Access Compliance Report Public Rights-of-Way (Pedestrian Signals)

Main Street: O_NEILL_DR Cross Street: O_NEILL_DR Location: SE

ADA ID: SGRK211026132020 Signal Type: One Push Button-Non APS Overall Compliance: No Severity Scores: BTN 1: 35 BTN 2: N/A No BTN: N/A

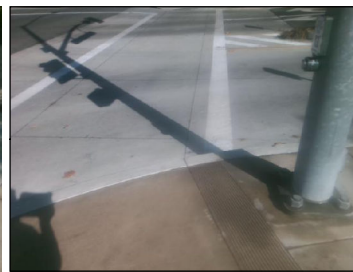
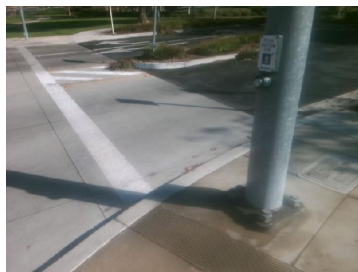
OC Std/PROW: R404.2, MUTCD 4e.08

Possible Solutions: Replace Signal Push Button With APS Button. Remove and Replace Clear Space.
